To: Mr. Tim Johnson, American TCB
From: David Waitt, Airespace
Subject: Inquiries regarding Certification application for FCC ID **QTZUSAPAP1200B**
Date: 1 April 2003

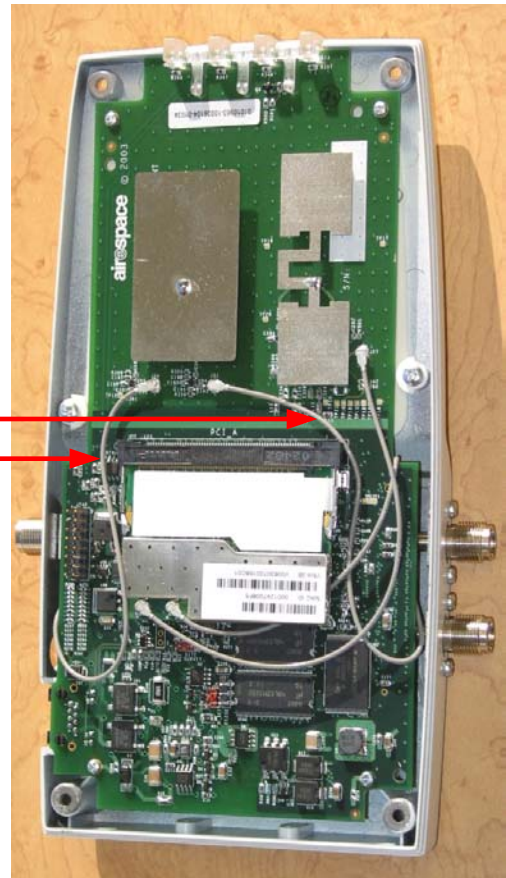
ATCB 2) This submittal appears to contain information regarding external antennas. However, it is not certain how the external antennas connect internally to the device. Please explain and provide photographs as necessary.

Airespace: The reverse TNC connectors used to support the use of external 2.4GHz antennas are connected to the main circuit board in the radio via short coaxial cables shown in the photos below. Note that the hardware is in place to support external 5 GHz antennas; however the configuration software does not support use of external 5 GHz antennas. Currently, until authorized by the commission, configuring the radio to operate with external 5GHz antennas is not possible. The photos on the next page illustrate the internal cables.

These cables connect the main PCB to the external 2.4 GHz antenna connectors

Cables used to connect the main PCB to the 2.4 GHz external antennas connectors

5GHz external antenna connector, in place, but not supported by the configuration software.
